Council Assessment Panel Agenda & Reports

17 March 2025

LODGEMENT DATE:	26 Sept 2024
RELEVANT AUTHORITY:	Assessment panel/Assessment manager at City of Norwood, Payneham & St Peters
PLANNING & DESIGN CODE VERSION:	P&D Code (in effect) Version 2024.17 12/9/2024
CATEGORY OF DEVELOPMENT:	Code Assessed - Performance Assessed
NOTIFICATION:	Yes
RECOMMENDING OFFICER:	Kieran Fairbrother, Senior Urban Planner
REFERRALS STATUTORY:	Nil
REFERRALS NON-STATUTORY:	David Brown, Heritage Advisor Matthew Cole, City Arborist

SHADOW DIAGRAM - 3PM SCALE: 1:200

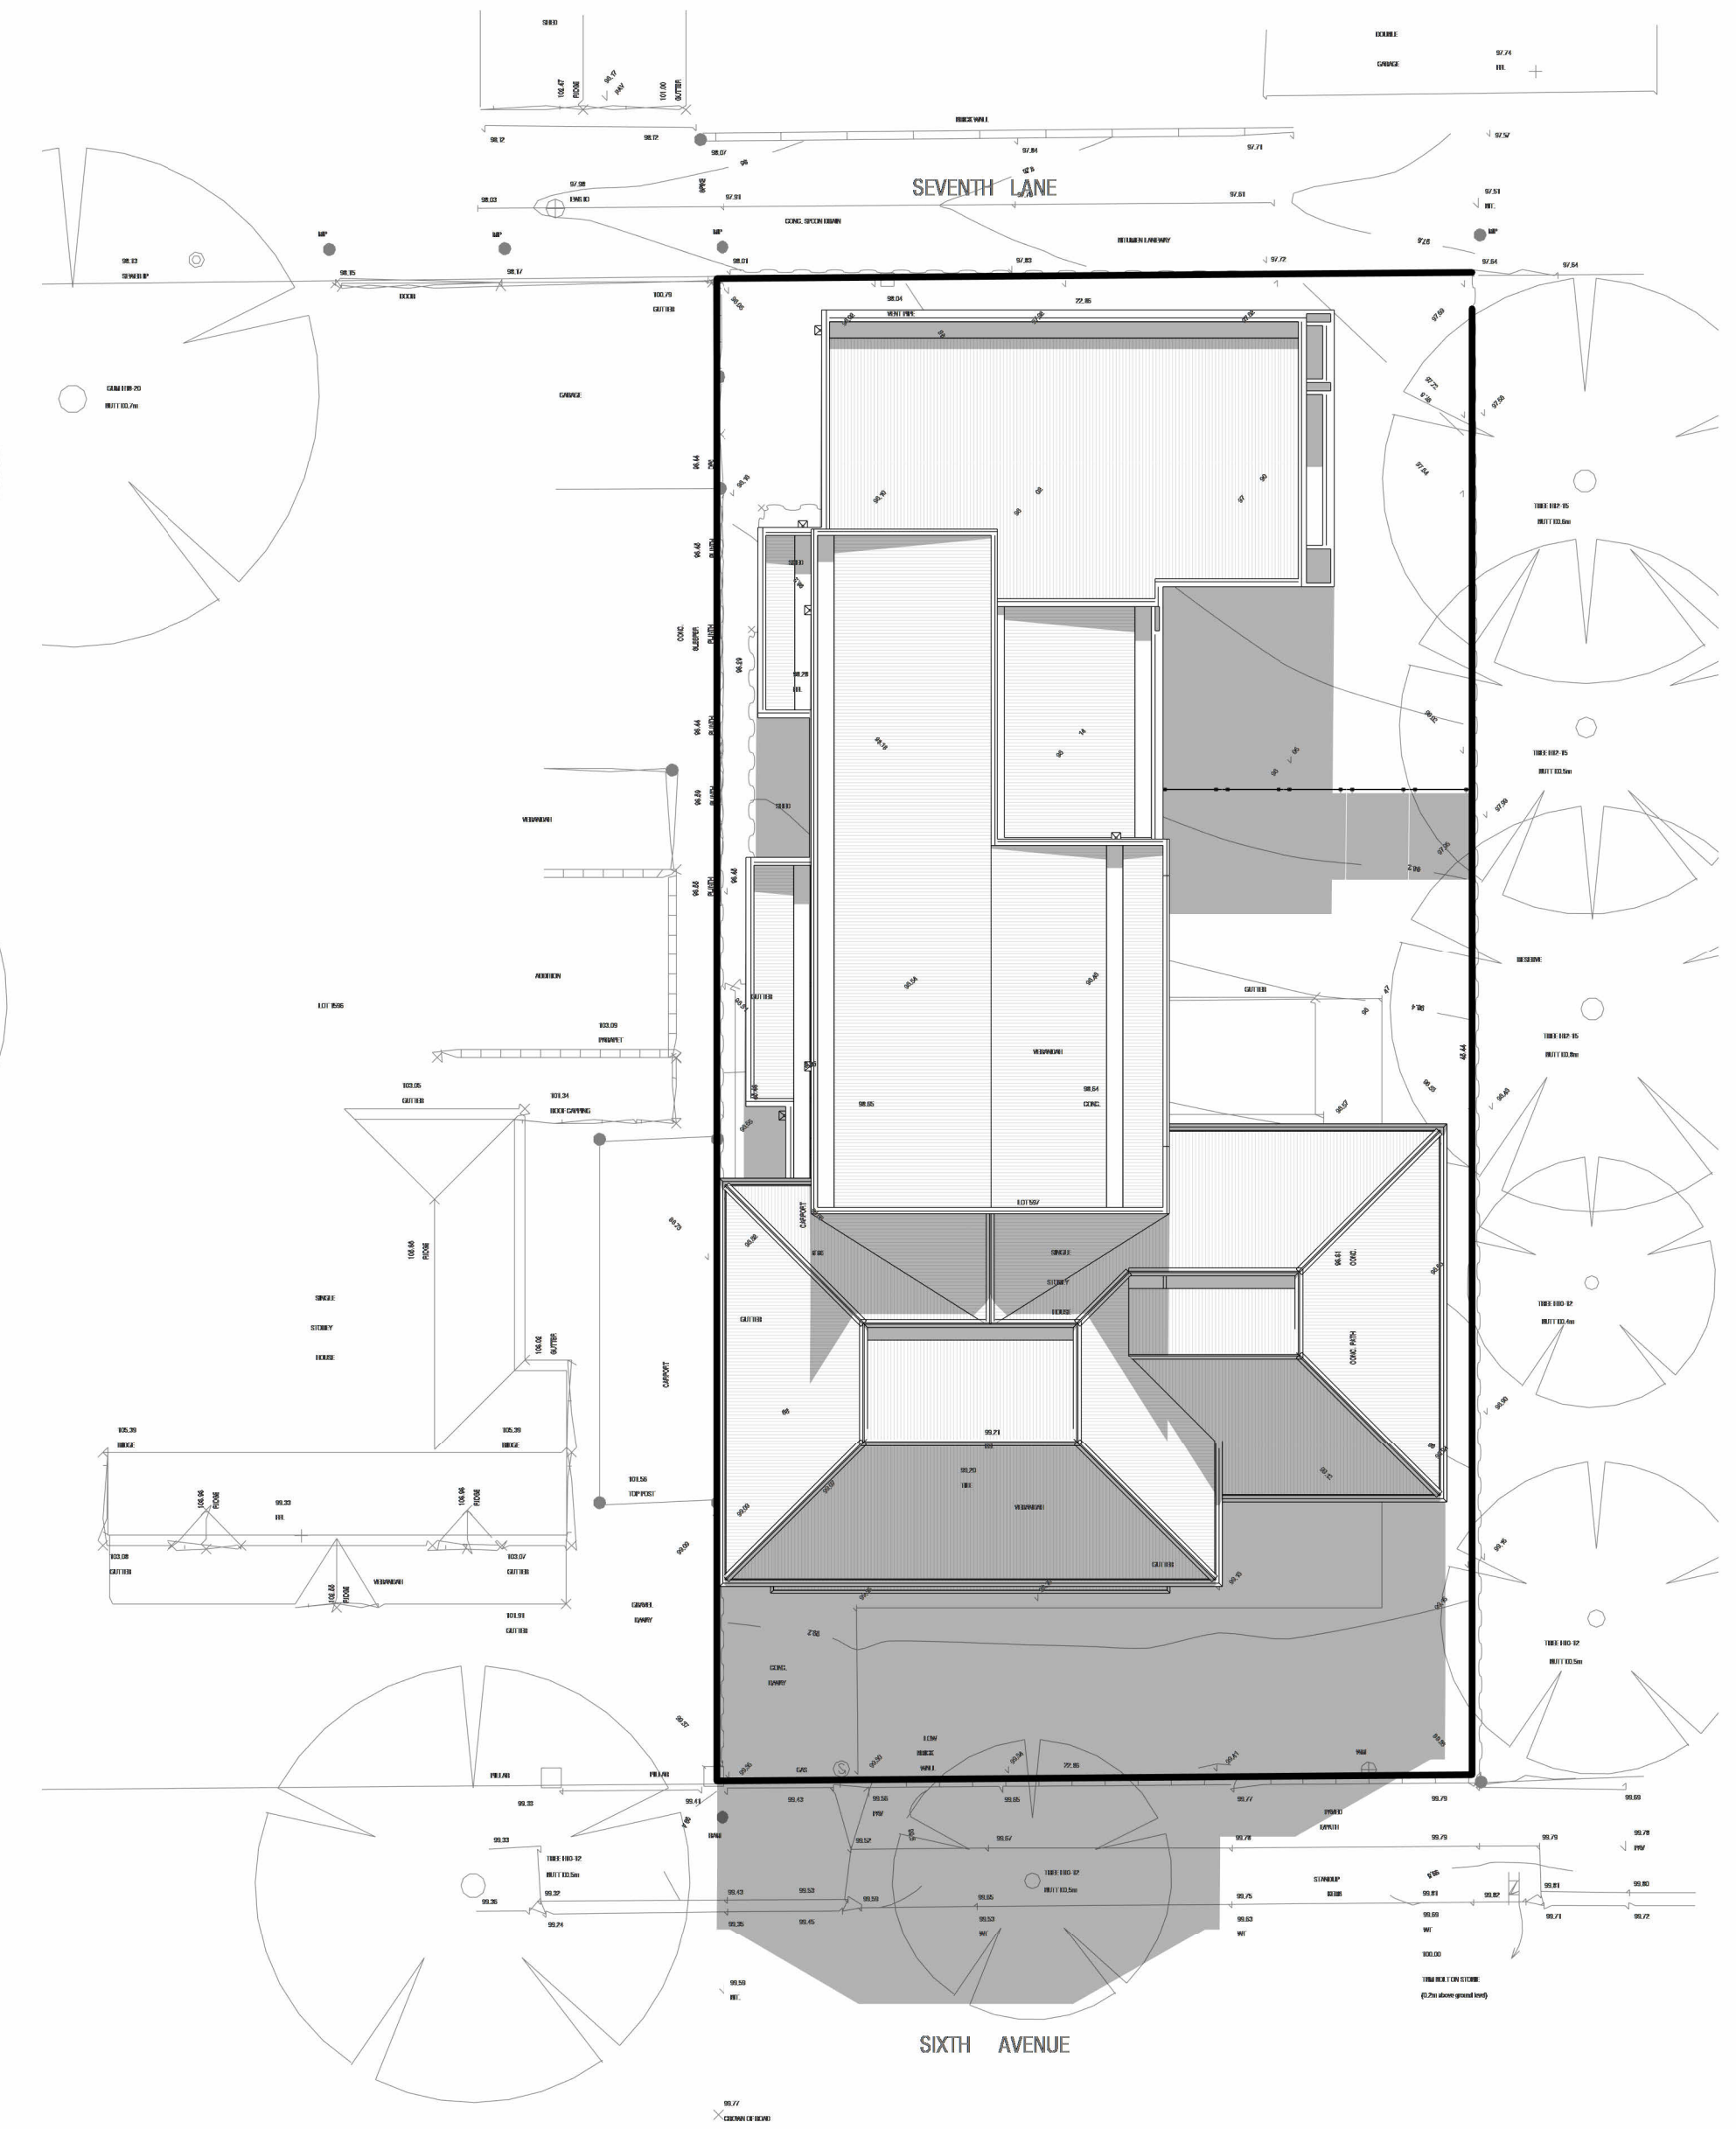
The adjacent dwelling at 46 Sixth Avenue has solar panels on the roof of their flat roof rear addition that will be impacted by the proposed development, as demonstrated by the shadow diagrams provided by the applicant (**Attachment 1**). These panels will be mostly shadowed during the morning period of the winter solstice, where one might expect the panels to have their lowest generating capacity because of the typically lower levels of sunlight. By the early afternoon of the winter solstice, however, the development does not provide any shadowing of these solar panels due to the northwest-southeast orientation of the two allotments. By inference, these solar panels will be largely unaffected by this development during summer, spring and autumn, when they have a larger generating capacity, because of the sun's higher angle in the sky. Accordingly, the development is considered to sufficiently accord with Performance Outcome 3.3 above.

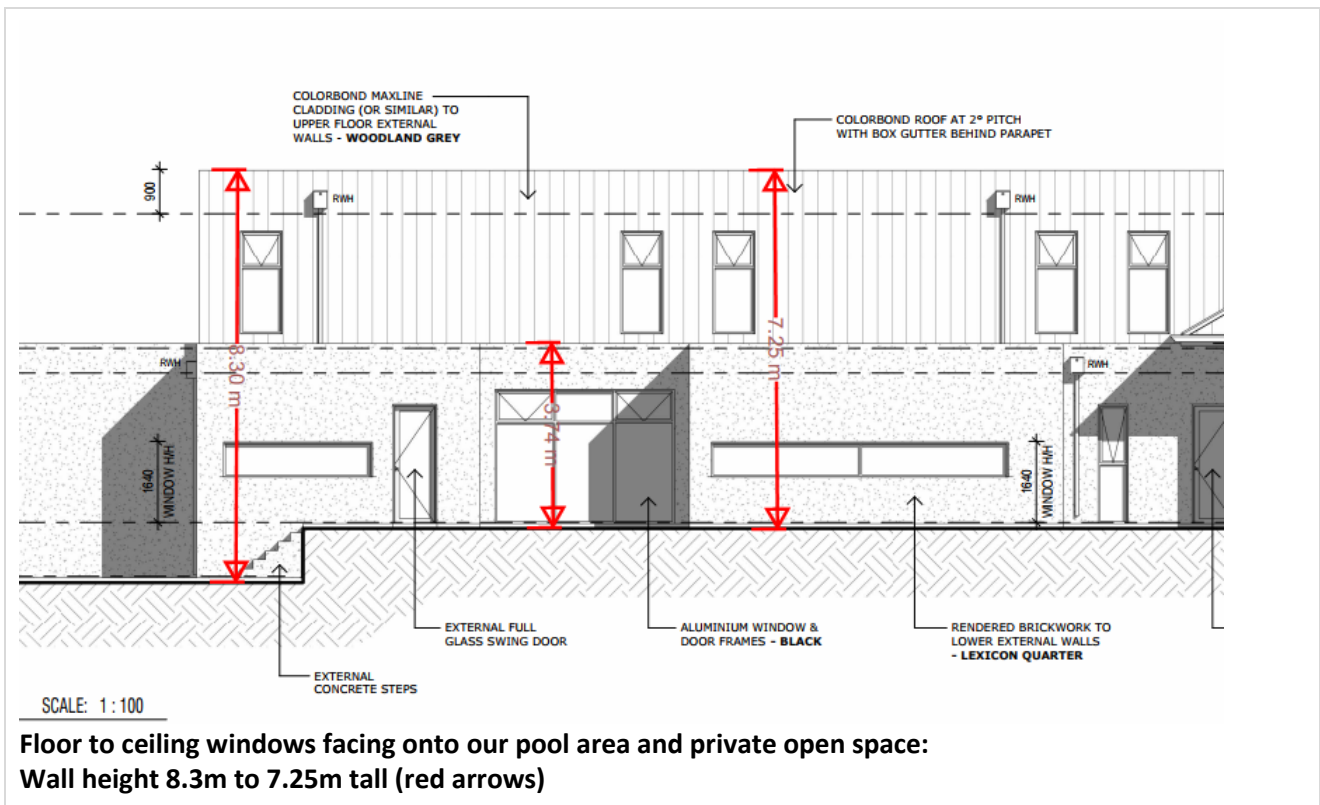
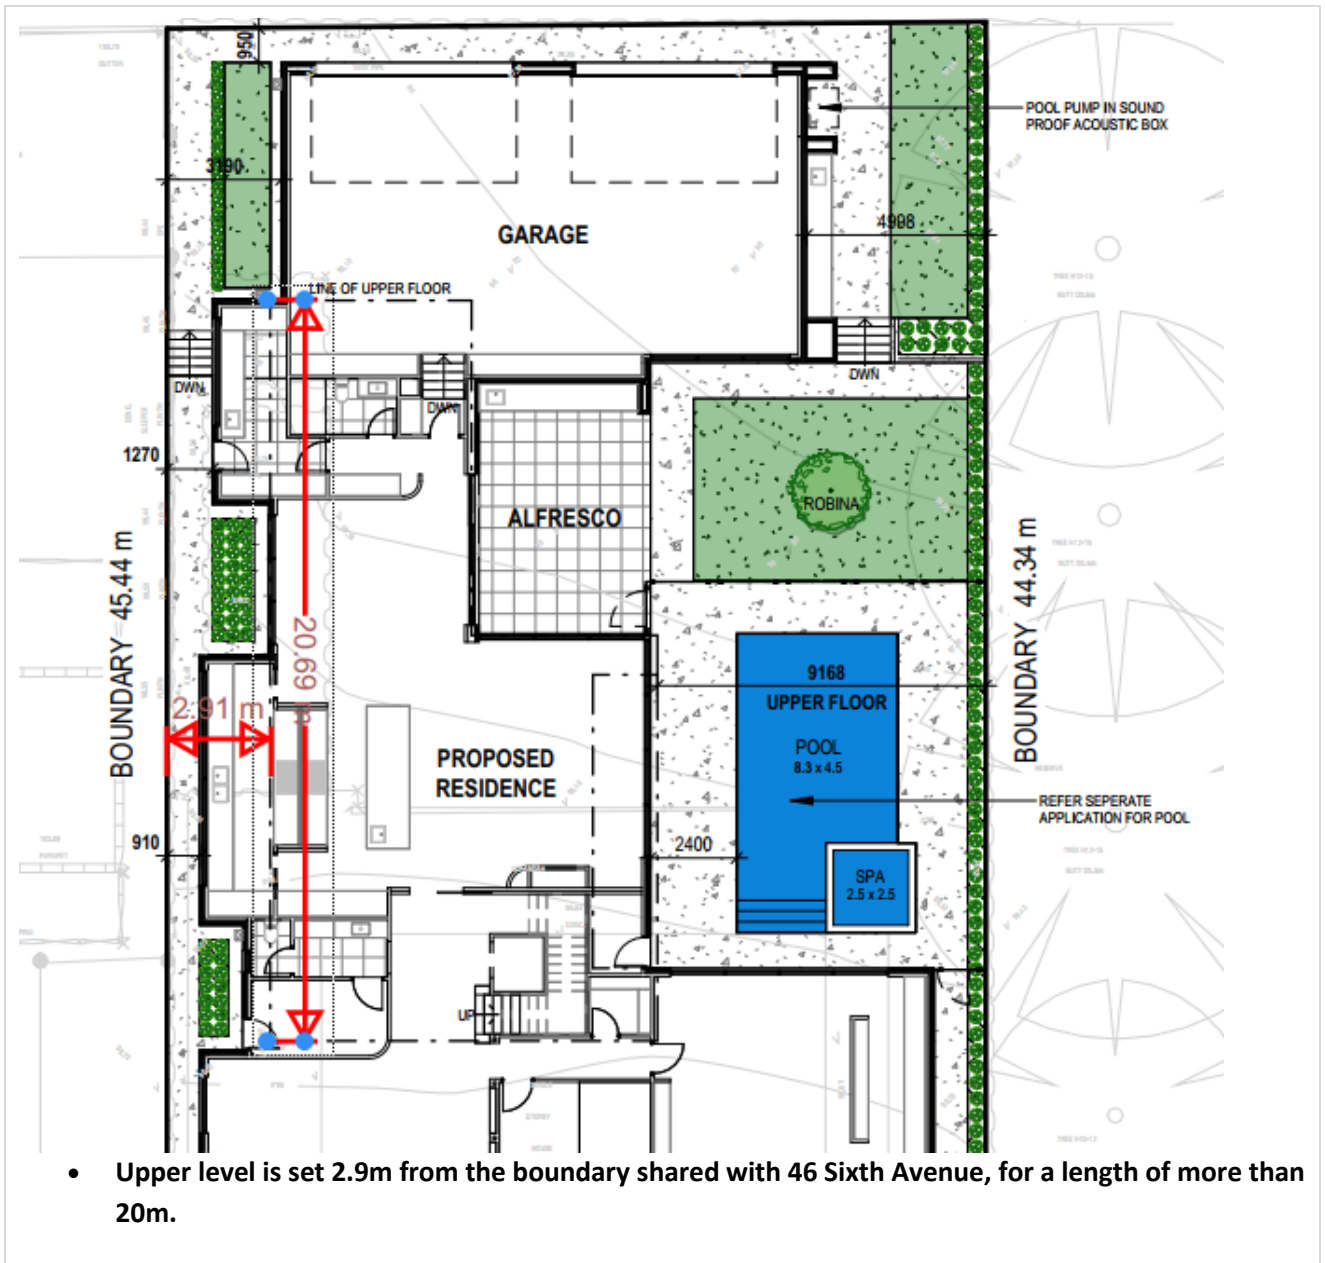
We particularly object to the height and extent of the proposed side boundary wall that faces our northern boundary. The setback requirements of DPF 8.1 (2)(c) applies (**highlighted above**). At ground floor level, the height of the proposed side wall exceeds 3m. A side boundary setback of between 910mm (ground level) and 3.19m (upper level) is proposed, adjacent to our side boundary. The ground floor level should be set back at least 1.9m from the side boundary, and the upper level set back at least 3.3m (wall height of 7.25m proposed, 4.25m of the wall is above 3m, $1/3$ of 4.25m = 1.42m, 1.9m + 1.42m = 3.3m). We note that a portion of the wall is 8.3m in height, and should therefore be setback even further from our side boundary.

The northerly aspect of our back yard will be significantly overshadowed by the 7.25m wall along the boundary. Photo taken 9:28am 2/12/24.

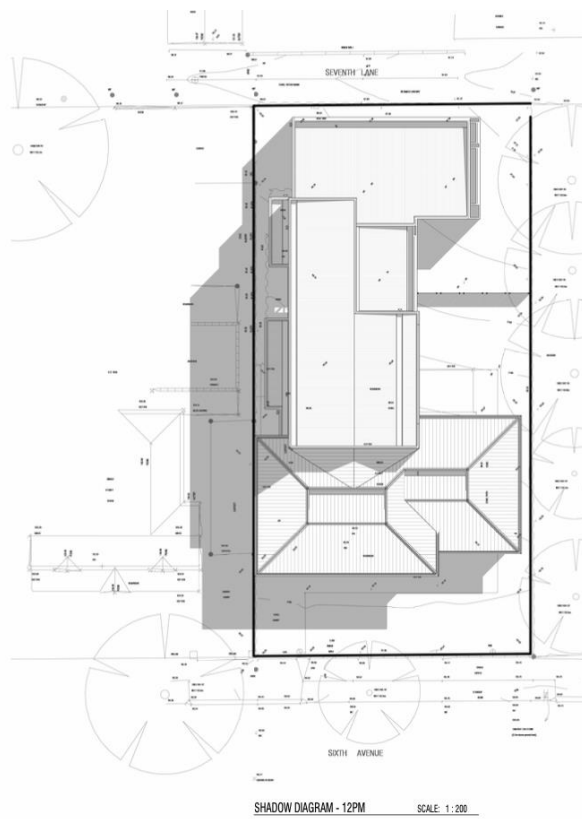
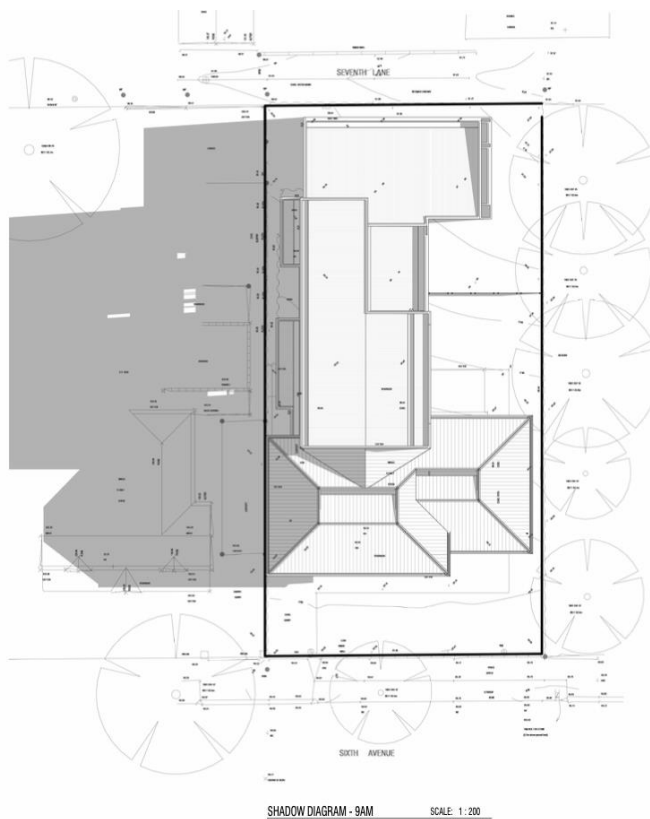
Notwithstanding the setback proposed, we also object to the length of two storey wall adjacent to our boundary of more than 20m, visible for the full extent of our rear private yard and swimming pool. This results in a significant visual impact, as well as unreasonable overshadowing of our yard and pool, as illustrated in the shadow diagrams submitted that show our back yard in shadow for most of the day in mid-winter. The upper level windows include floor to ceiling glass that will allow clear views from the upper level into our private rear yard and swimming pool.

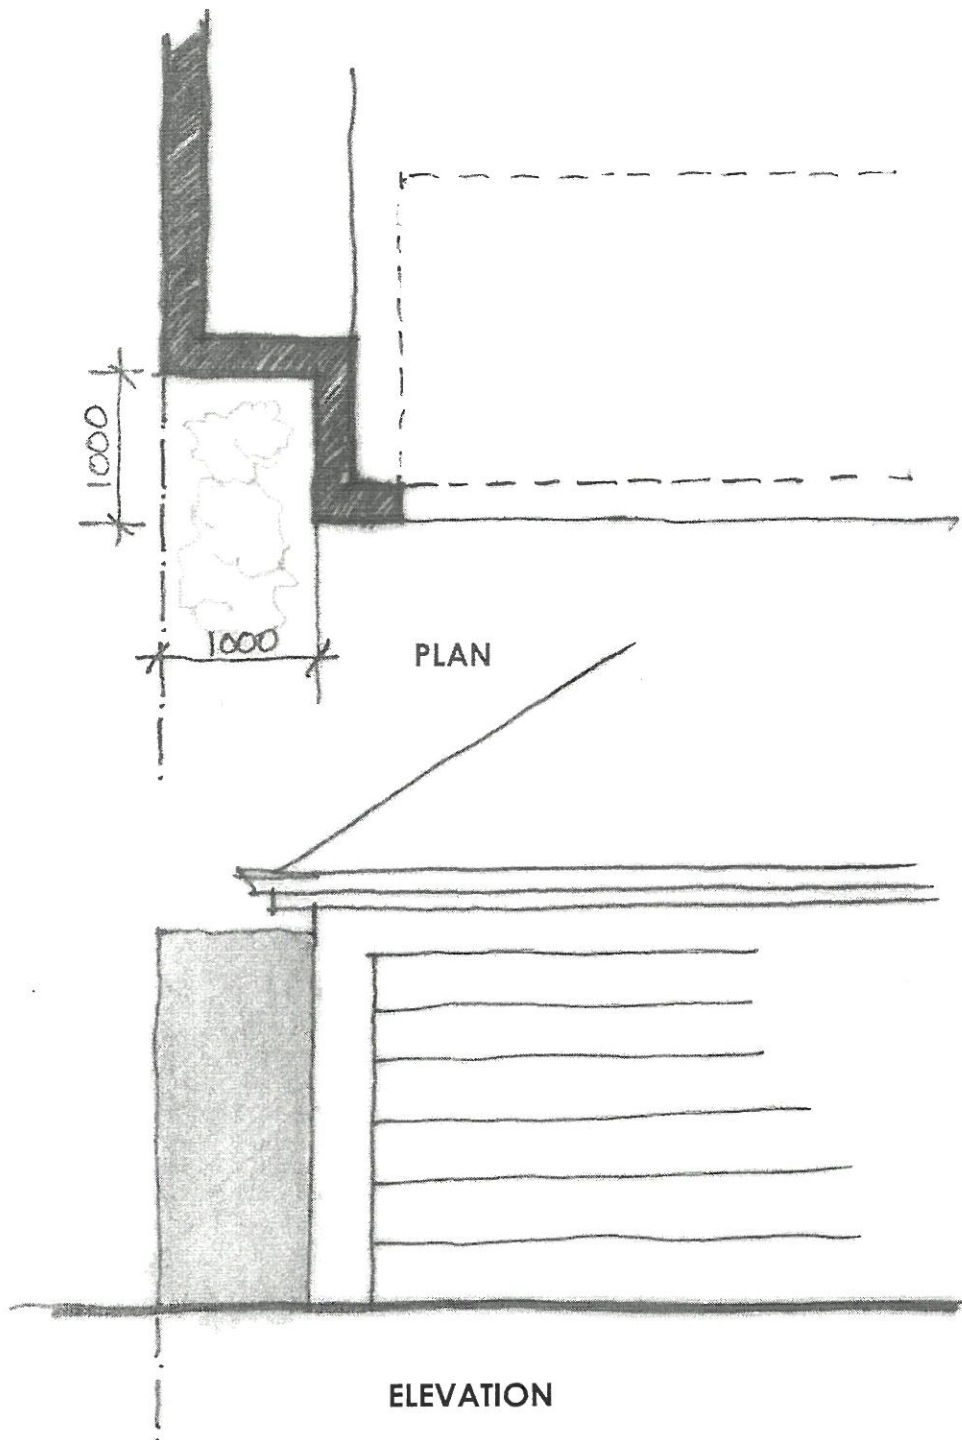
The obvious way to fix this would be to increase the ridge height for that roof so that it covers the whole of the upper floor height (though obviously oblique views would still be possible, as is the case with those other examples above). While increasing the pitch would hide this even further, the proposed 35 degree pitch is already at the upper end of what would be considered to be consistent with surrounding roof forms as sought by the Character Area Overlay, so I think the pitch should not be increased beyond the 35 degrees already proposed.
